Re: Final Report of Affordable Housing Overlay (AHO) Design Consultation Procedure Compliance Certification
21 Walden Square Road, Cambridge, MA – Response to Comments

Part I: Suggestions for Further Study from the Final Report of Affordable Housing Overlay (AHO) Design Consultation Procedure Compliance Certification dated July 22, 2024

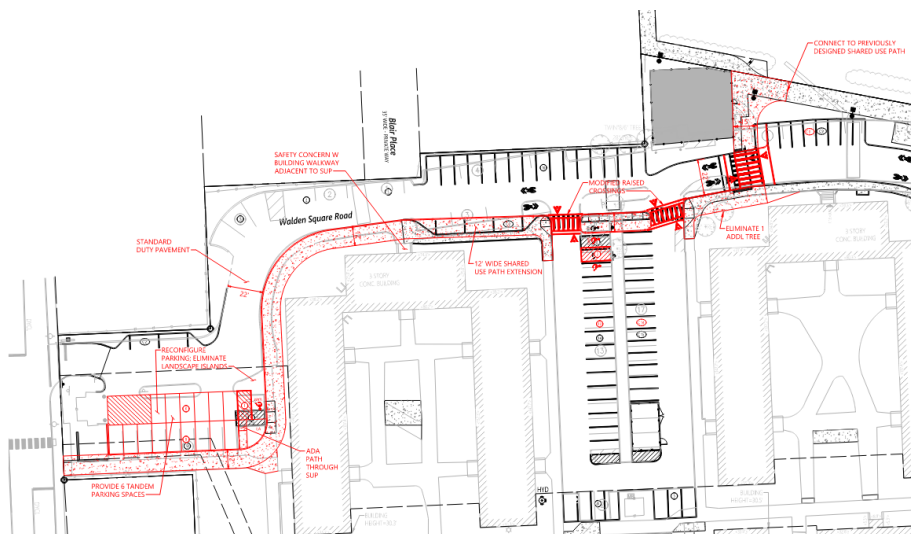
1. Staff recommends that further study be given to the vehicular, pedestrian, and bicycle connectivity to and through the site. The intended routes for pedestrians and bicyclists should be intuitively clear, not dependent on signage.
 - a. Clarify the preferred route for east-bound people walking or bicycling from the western part of Walden Square Road to the Yerxa Road Underpass. A smoother and more visually apparent connection to the new path on the north side of Building A should be investigated.

The preferred route for peds & bikes from the western part of Walden Square Road to the Yerxa underpass has been revised to include a shared use path extension along the south side of Walden Square Road as discussed with Planning staff. The revised site plan detailing the shared use path is included as Enclosure 1 to this memo.

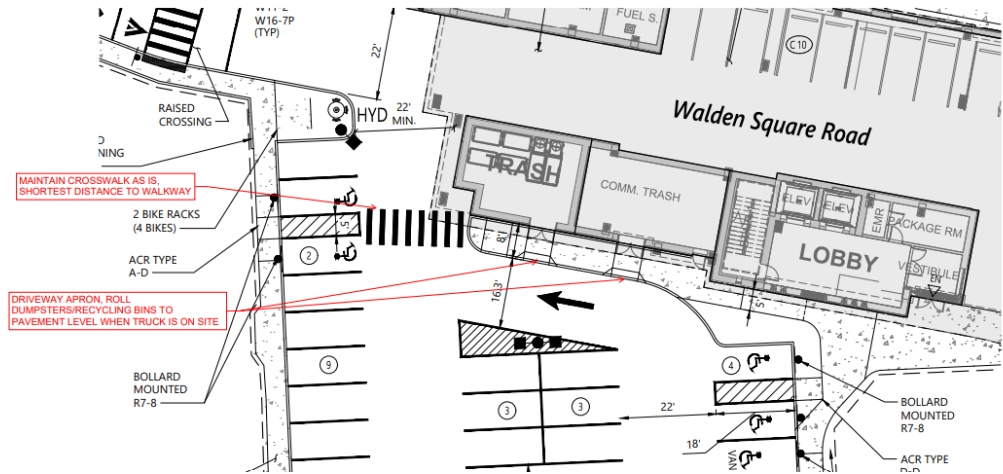
- c. The new pedestrian path along the south side of Building A is indicated only by painted markings. A raised sidewalk, separate from the parking lot and with a curb cut to the trash room would be preferable. In addition, it would be preferable to create a more direct route to this path for east-bound pedestrians coming from the sidewalk on the south side of the western part of Walden Square Road.

The pedestrian path has been revised to note a raised sidewalk with a driveway apron along the location of the doors to the trash and recycling rooms/enclosures. The proposed path provides the shortest distance to the adjacent sidewalk to the west of Building A and provides clearer site lines at the intersection. We will proceed with this approach pending final review by the Cambridge Fire Department.

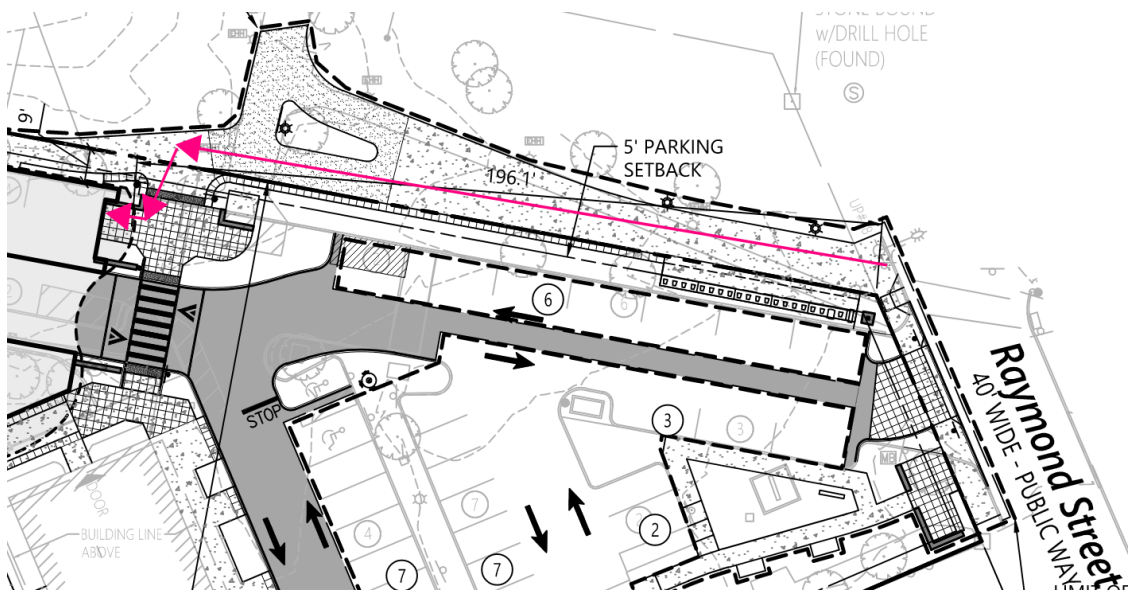
- d. Clarify the route for people bicycling west-bound on Walden Square Road from Raymond Street to the bicycle storage room at the east end of Building A. The configuration of the paved area and planting outside the bike room seems to not address this desire line.

The preferred route is to utilize the shared use path from Raymond Street to the bike room at the east end of Building A. The plaza is intended to give both pedestrians and cyclists additional room to maneuver based on the proximity to the different paths connecting the site.

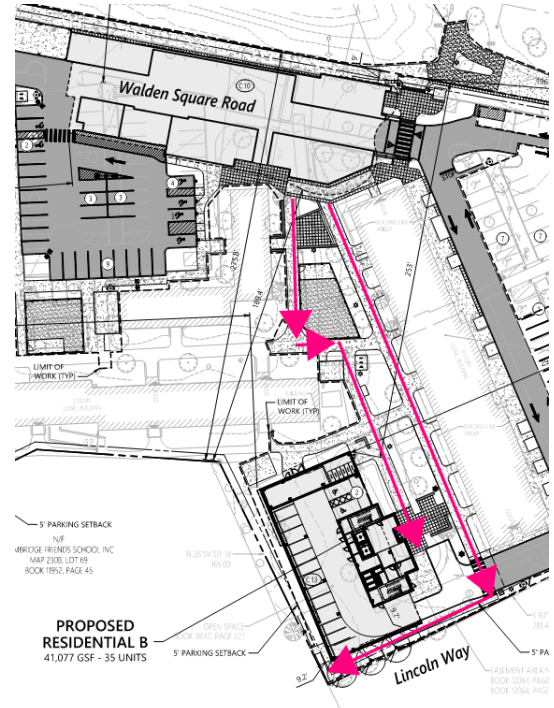
- 2. At the east end of Building A, a pedestrian crosswalk across Walden Square Road connects the path from the Yerxa Underpass to the east/west path on the south side of Building A and to the sidewalk on the east side of Building 21. Consideration could be given adjusting the designs of the crosswalk and the associated areas of pedestrian pavement to more strongly prioritize pedestrians over vehicular traffic and to create a more direct connection to the Yerxa underpass.

Pedestrian movements across this location are prioritized through the use of the wide raised crossing, along with the rapid rectangular flashing beacon (RRFB) signage and lights at the crossing. The offset of the crossing to the Yerxa underpass is preferred so that bicyclists coming south down the Yerxa Underpass are slowed down as they approach the shared use path and crosswalk. Additionally, realigning the crosswalk would impact existing non-conforming parking that is outside the scope of this project.

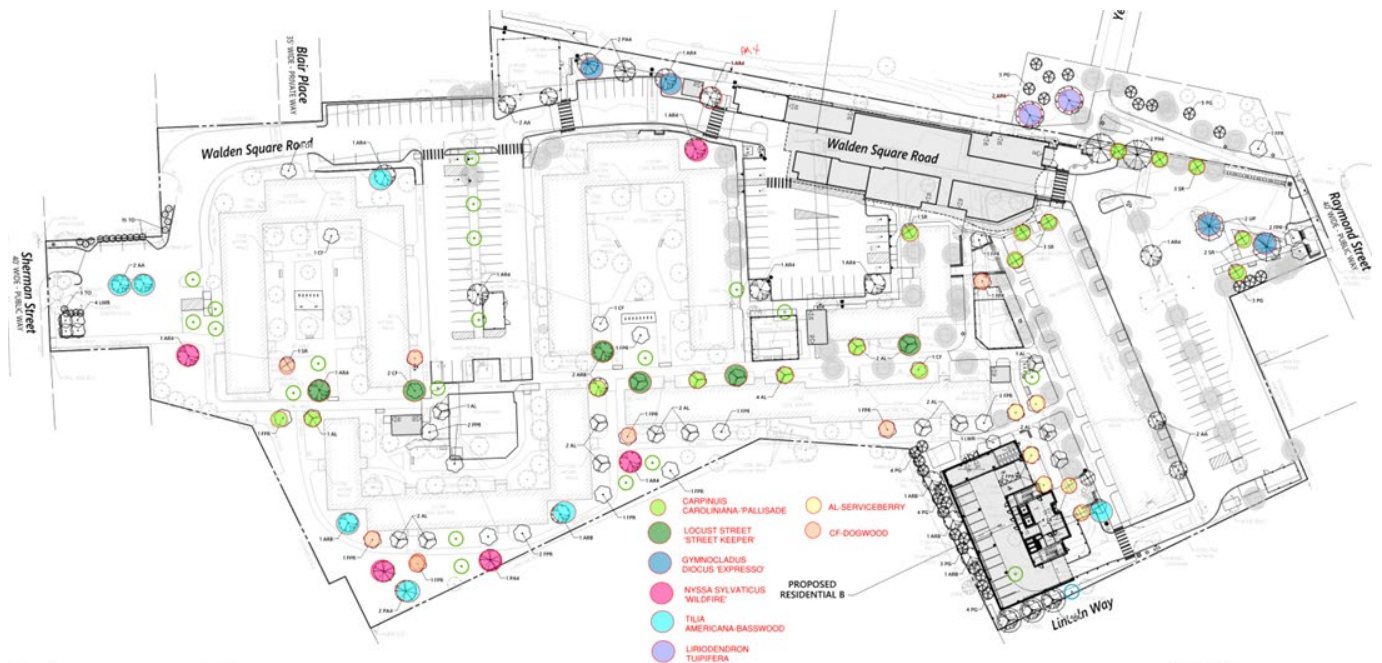
- b. Provide additional canopy shade trees inside and to the east, west, and south of the play areas.

Existing mature shade trees have been retained within or proximate to the proposed and enlarged play areas. New shade trees were added at the play area furthest West on the plan to add additional shade at that play area.

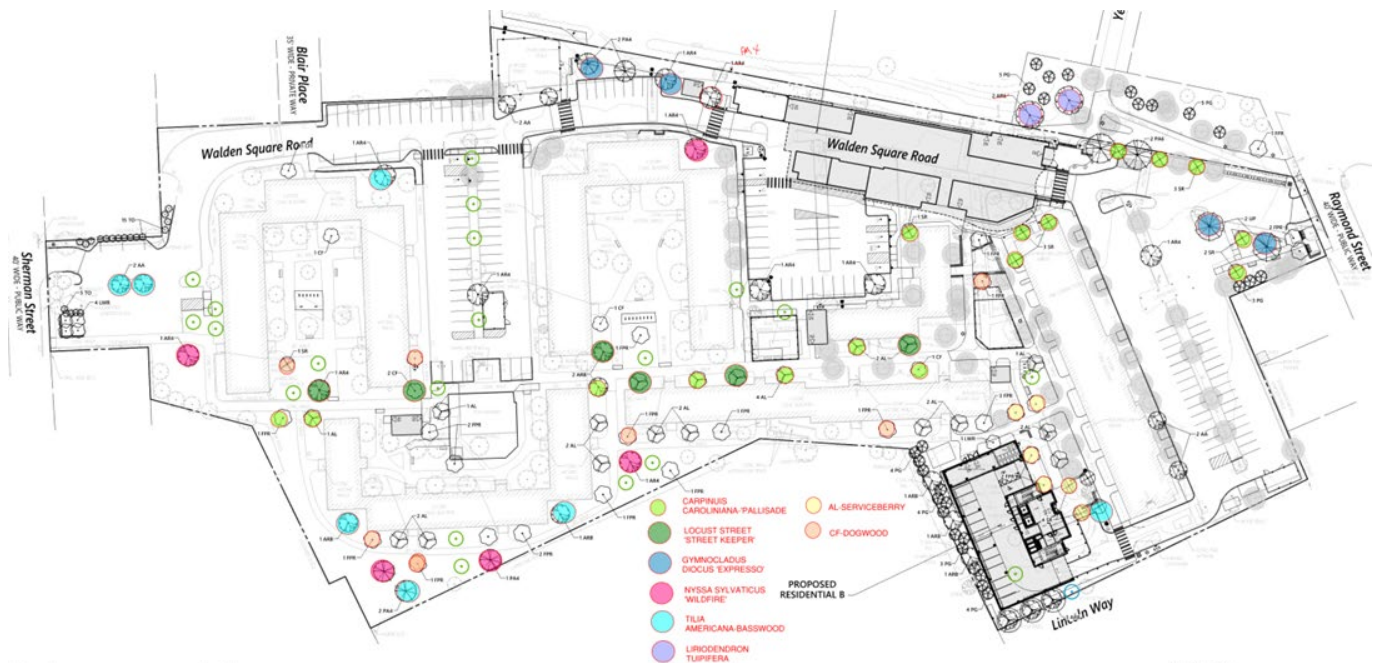
- a. Canopy trees could be planted in and around the playground areas, including the one where very large existing tree is proposed to be removed. It is common in City play areas to also have trees inside the play fence, located outside of any equipment fall zones to try and get shade where the children need it most. (Sennott Park and Rafferty Park are good examples)

The updated tree plan and site plan show the retention of existing mature trees within or proximate to the proposed play areas to provide more shade to the playground areas.
